ADDENDUM NO. 4

Reference: Residential Halls Buildings 2 and 3
Weber State University – Ogden, Utah
DFCM Project No. 10176810 and 11008810

Subject: **Addendum No. 4**

D4 SECTION

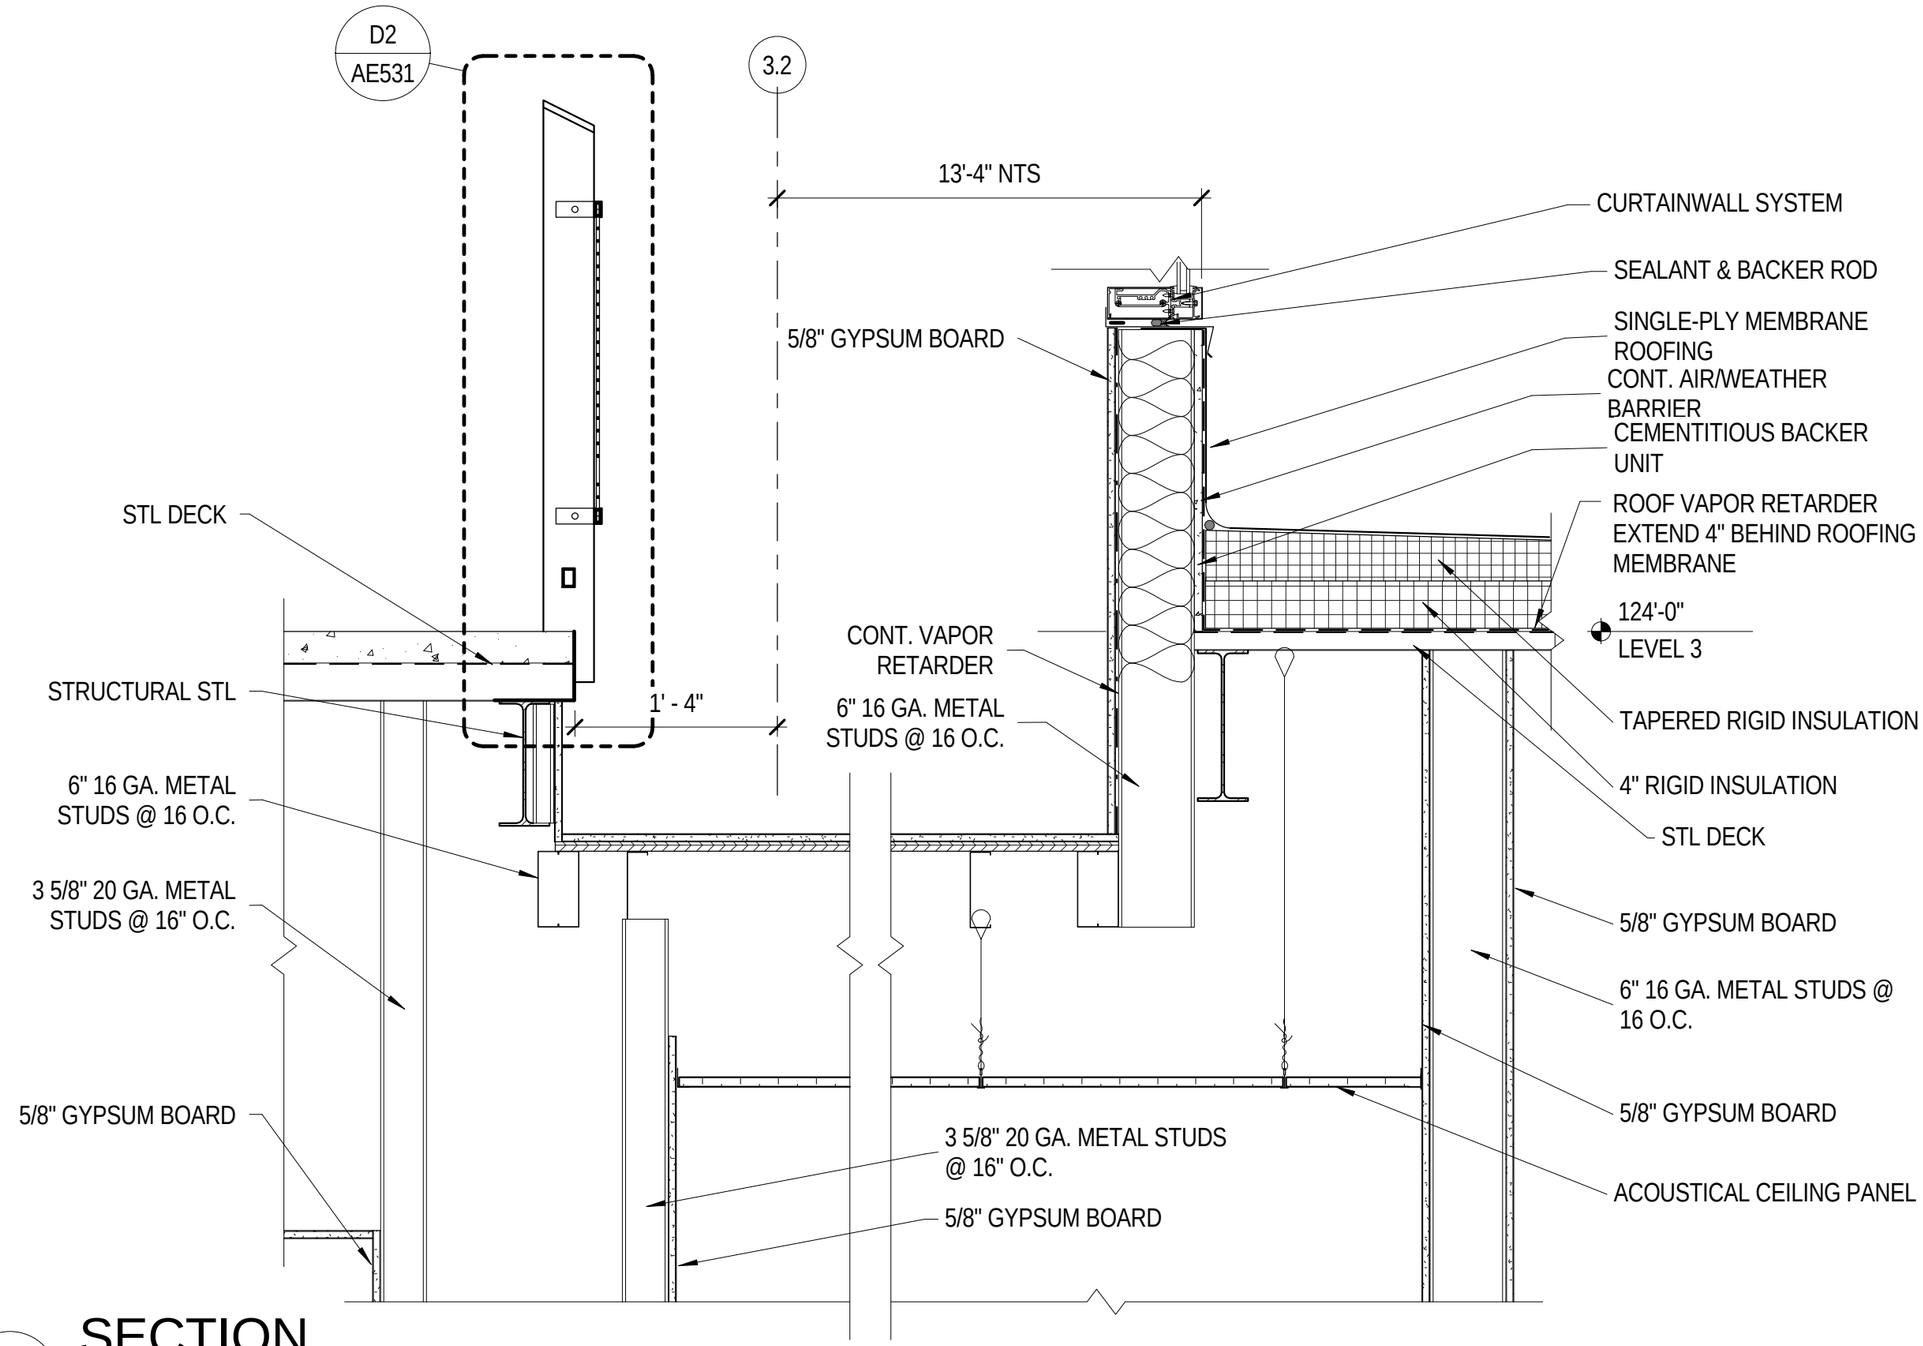
A. Revise stud framing below curtain wall in Detail D4/AE505 to include stud framing connection to structural steel as shown in attached AD04_A08.

E1

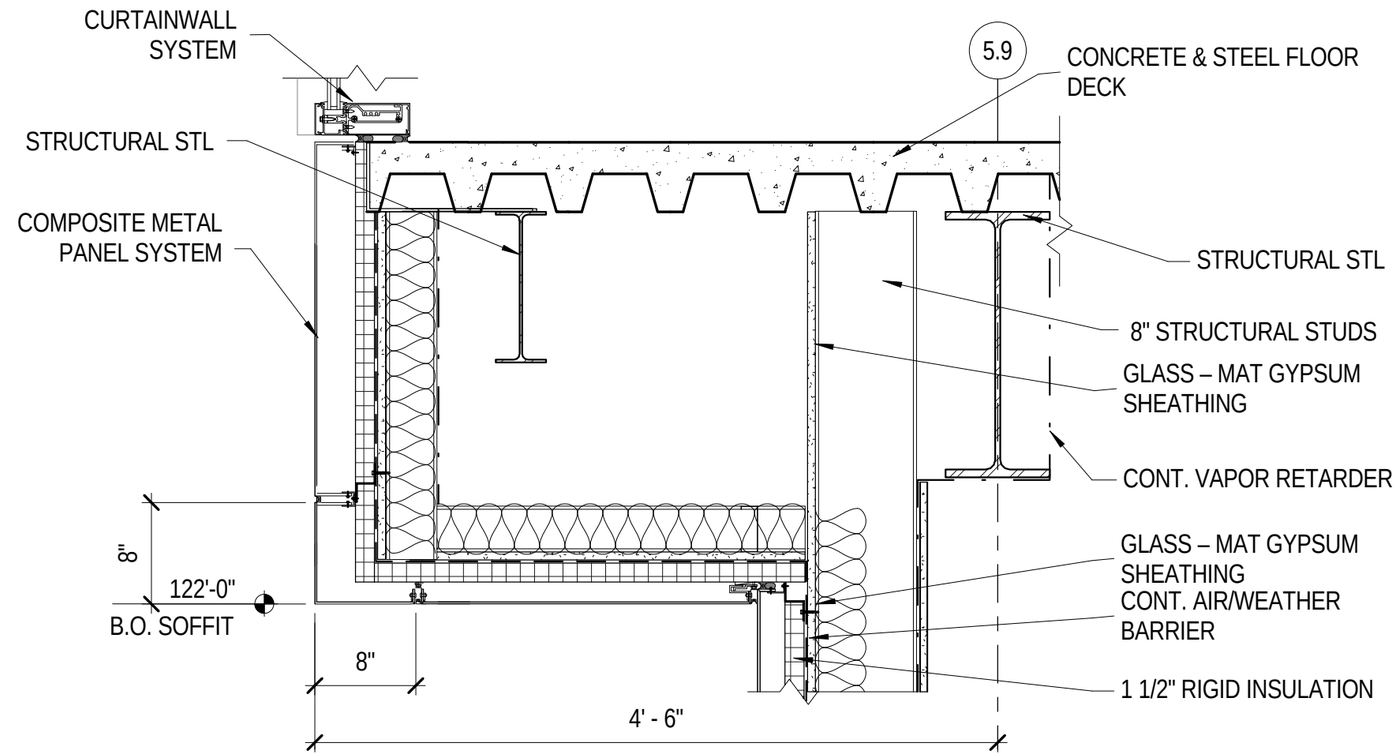
A. Revise Detail E1/AE506 to show Grid 5.9 and 8″ structural stud framing. See attached AD04_A09.

C1 DETAIL

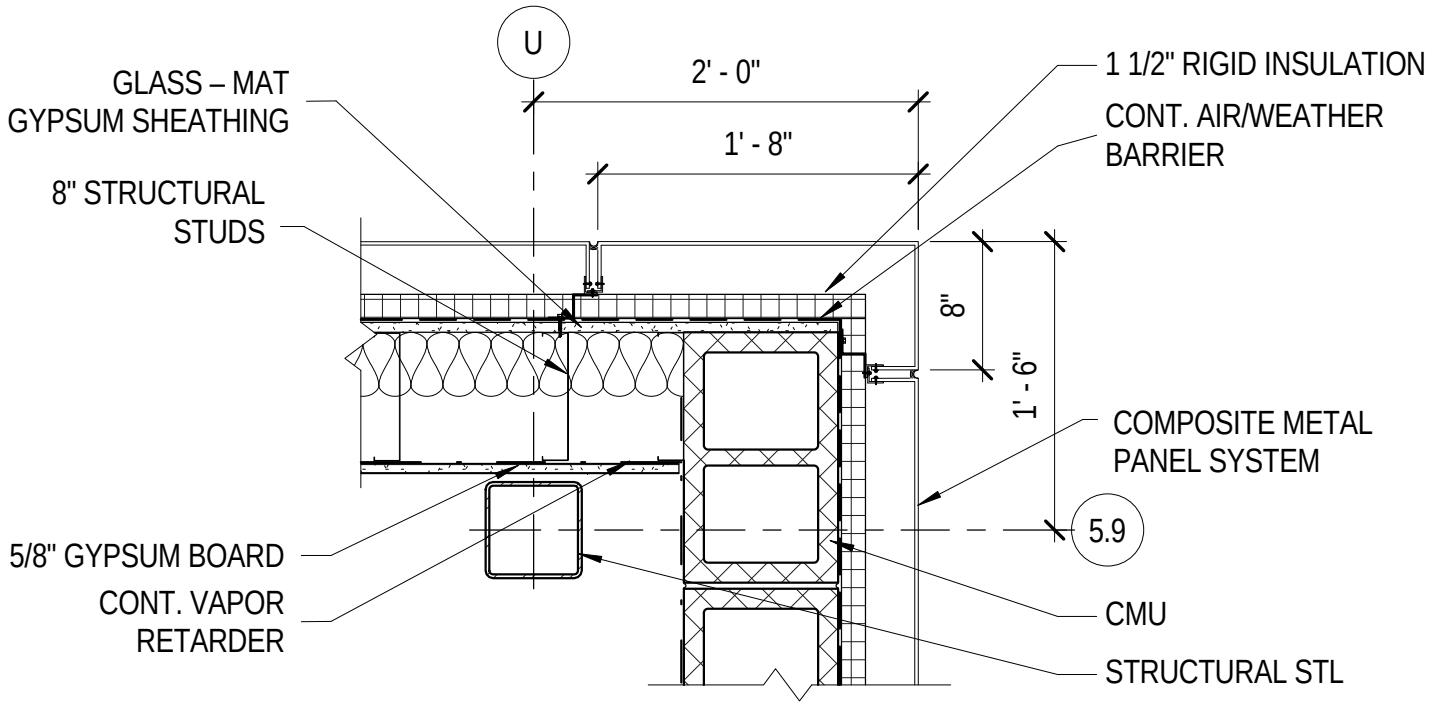
A. Revise Detail C1/AE508 to show 8″ structural stud framing. See attached AD04_A10.

WINDOW TYPE 19

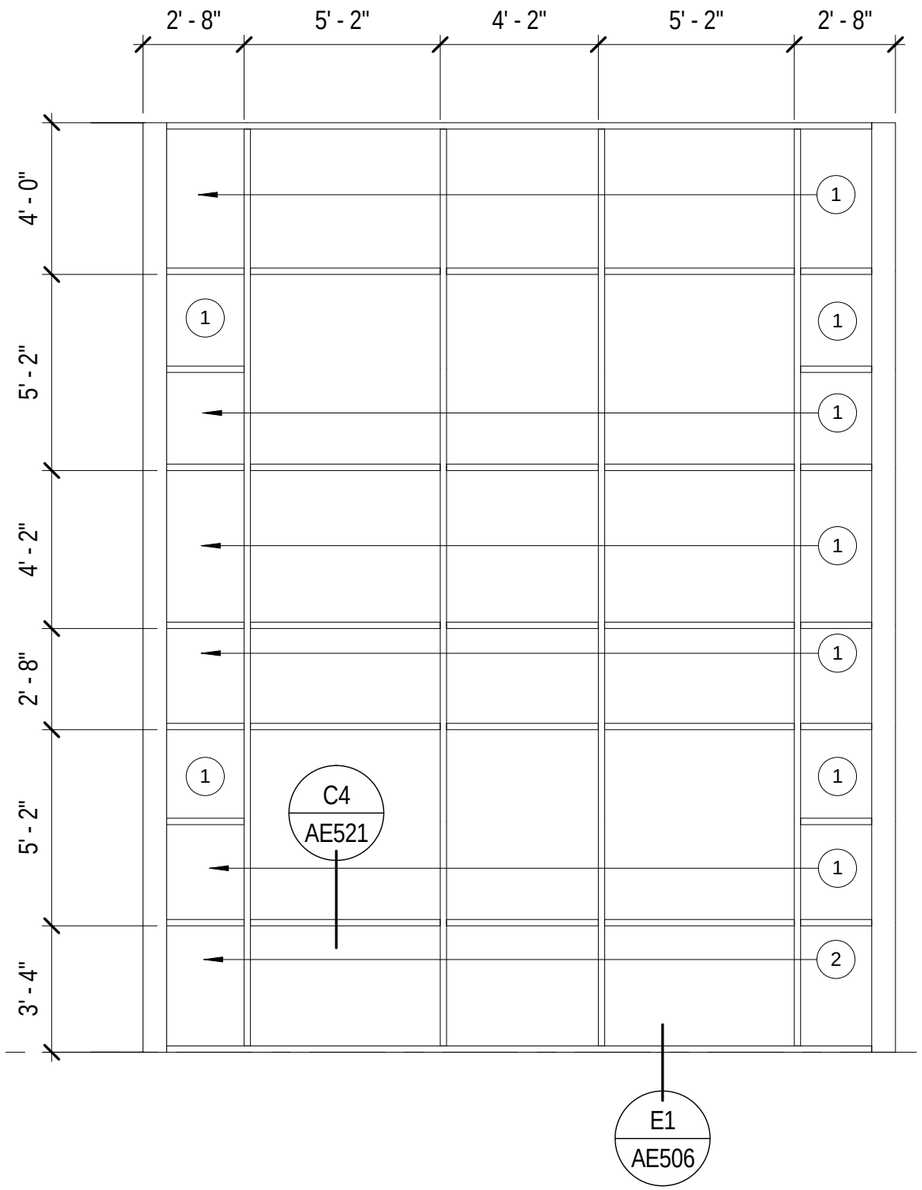
A. Update Window Types 18, 19, and 20 to show dimensions as shown in attached AD04_A11

2 WALL SECTION
SCALE: 3/4" = 1'-0"

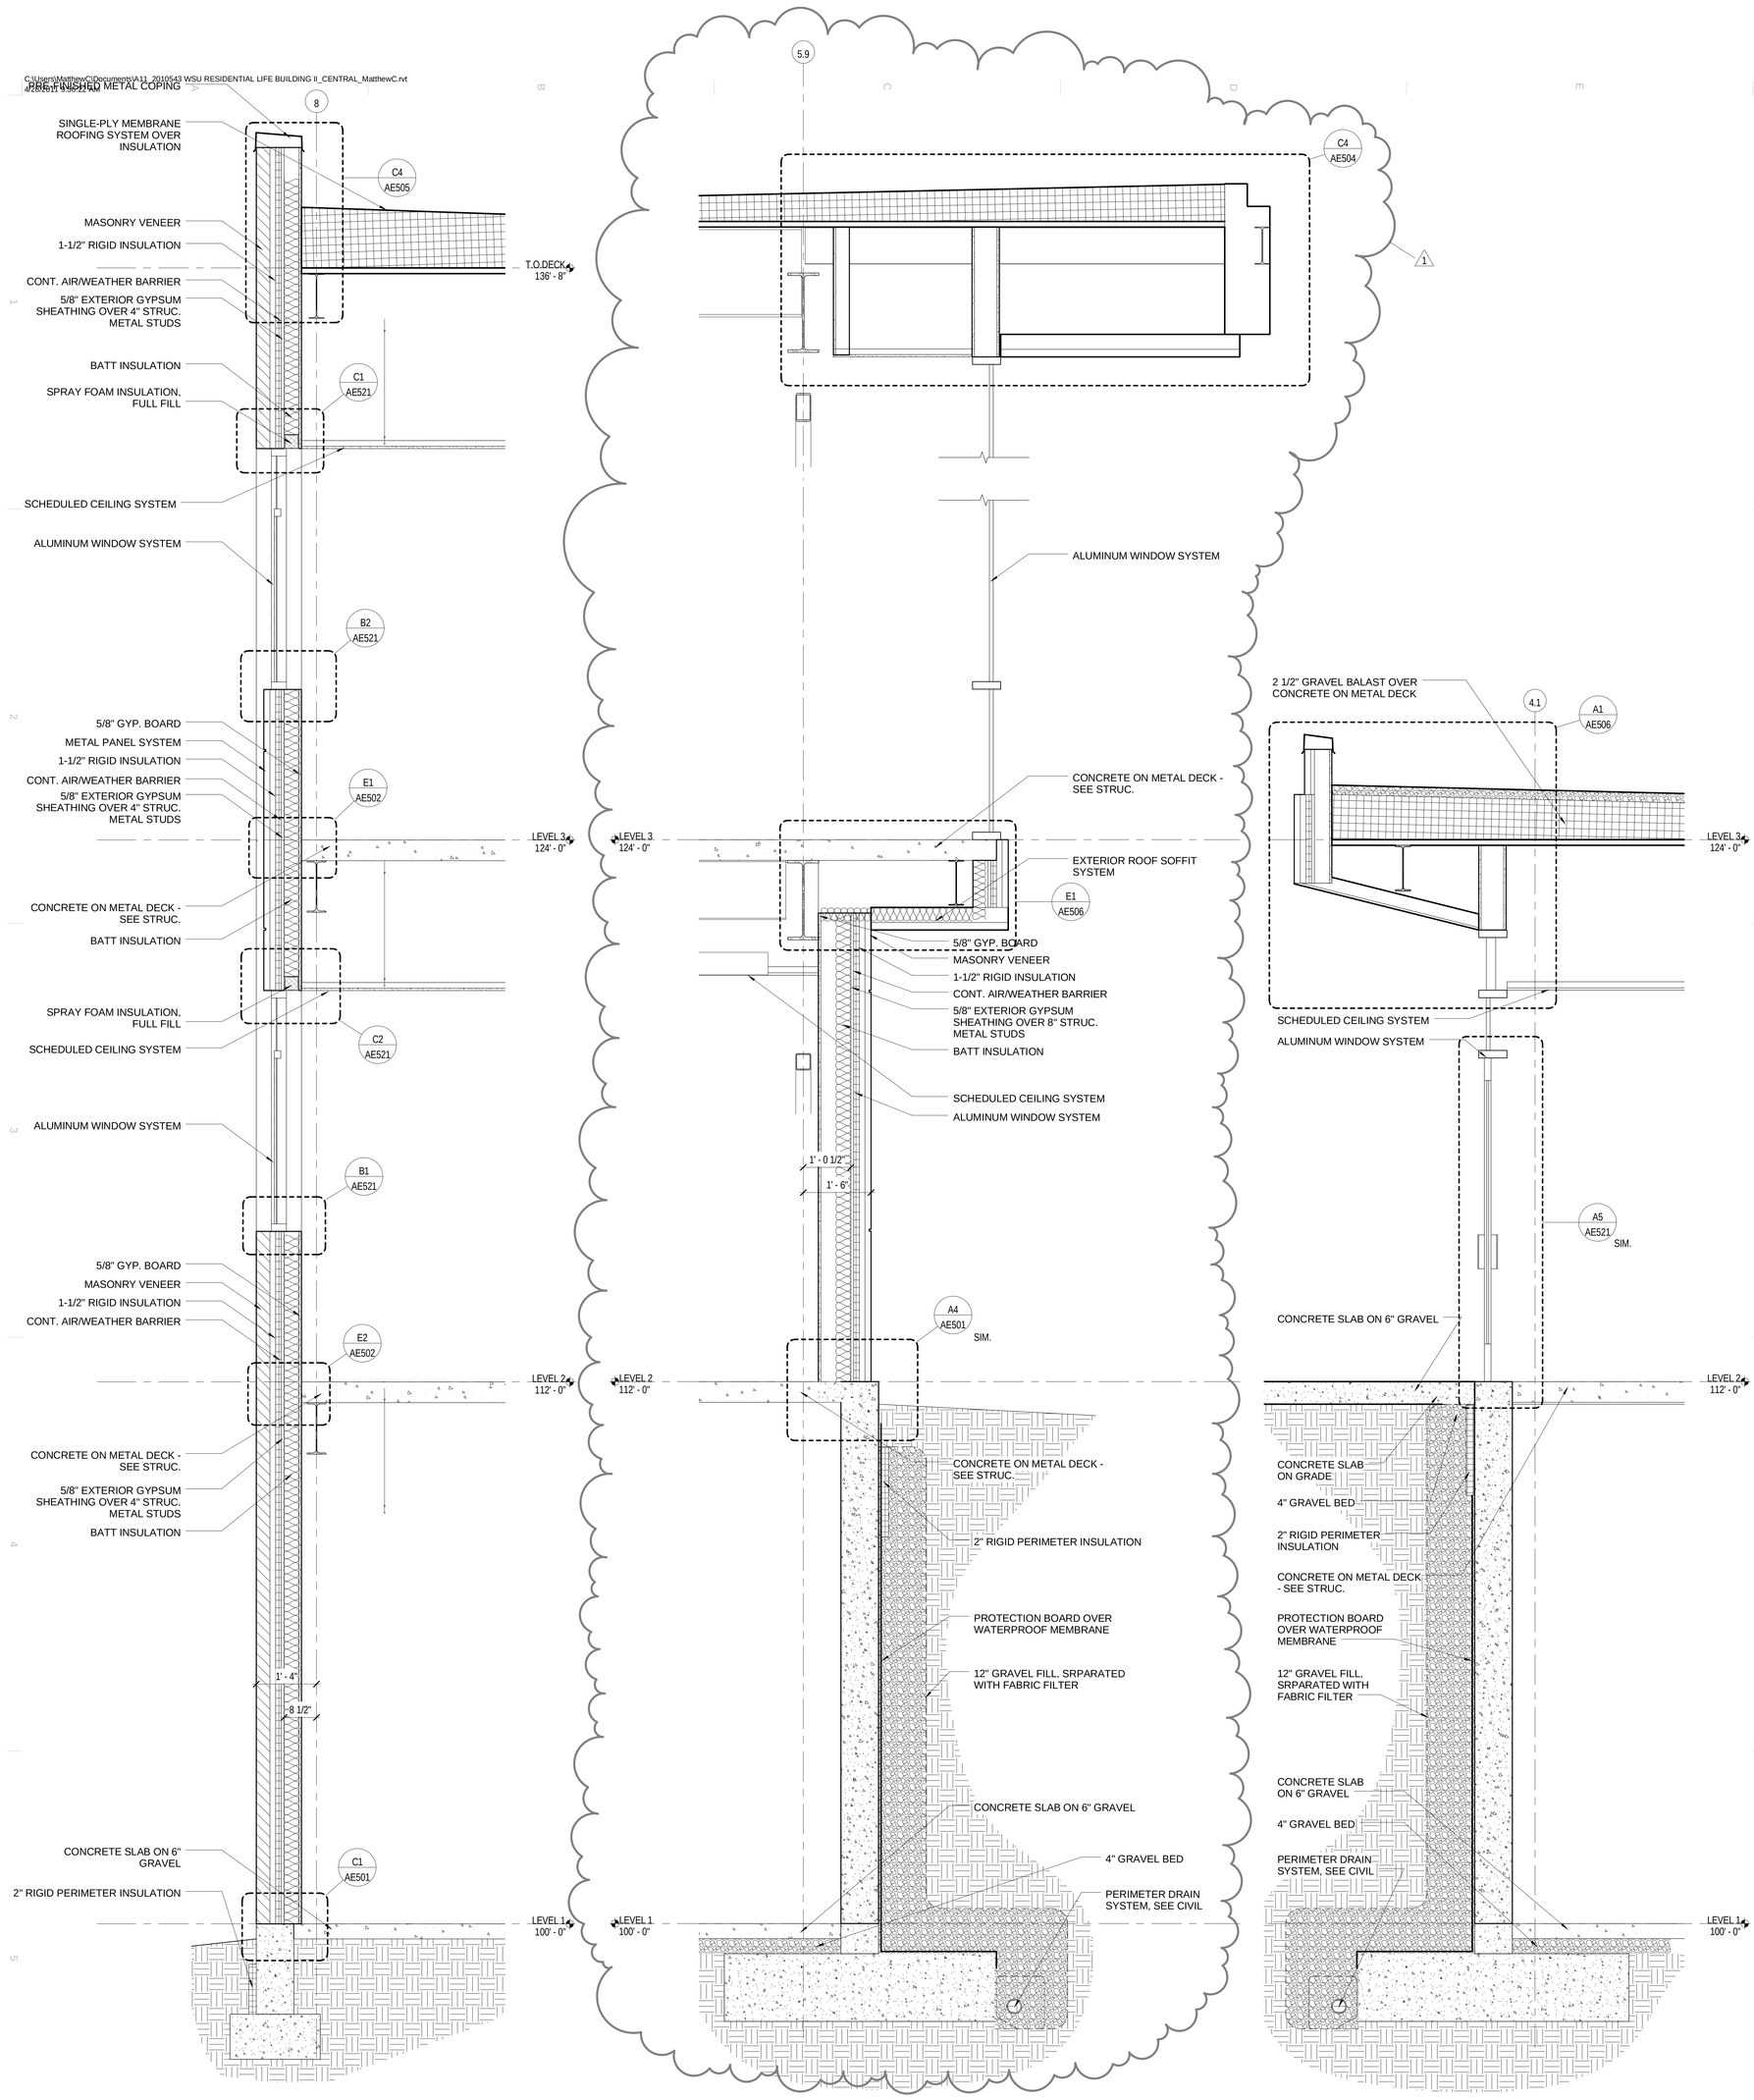
A. Revise Section 2 to show 8″ structural stud framing as shown on the attached Sheet AE304.

LATERAL FORCE RESISTING ELEMENT KEY PLAN L

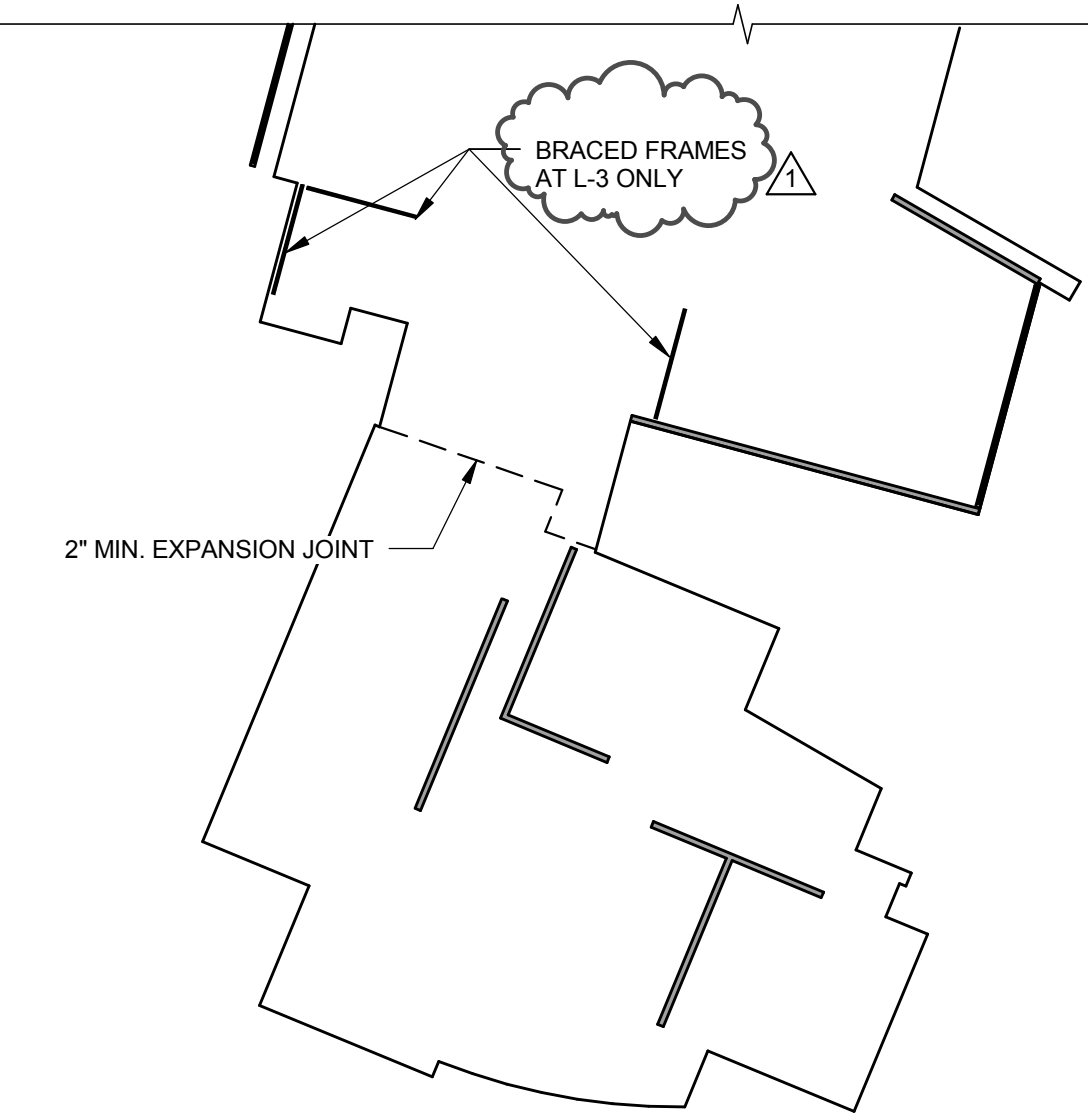
Sheet SG601
-A typo was corrected in the Lateral Force Resisting Element Key Plan. Please see the attached sheet AD04_S01.
